## HENDERSON COUNTY PLANNING BOARD

**SUBJECT:** Phase I Development Plan for Seven Falls

#### Phase I Development Plan for Seven Falls Golf and River Club Major Subdivision (File # 07-M19)

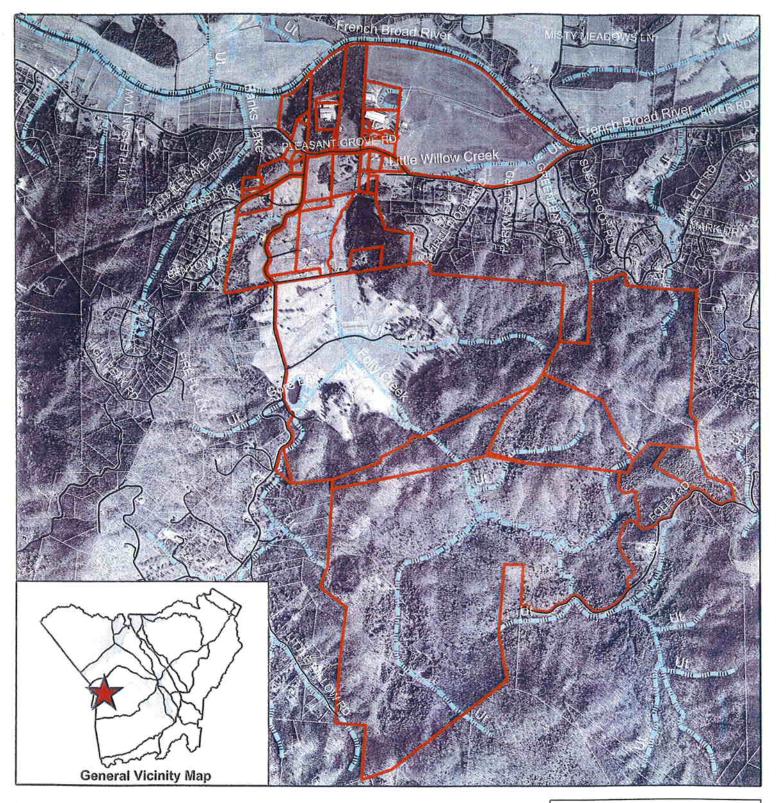
19. **Slopes.** Below is a slopes map of the approximate location of Phase I. This map has been provided for informational purposes only. Pursuant to the goals of the CCP, the applicant should work to protect steep slopes and leave them in their natural state with only limited development. Note: Henderson County does not have any regulations for development on steep slopes. The Planning Board can only require the applicant to meet the minimum standards of the Subdivision Ordinance.
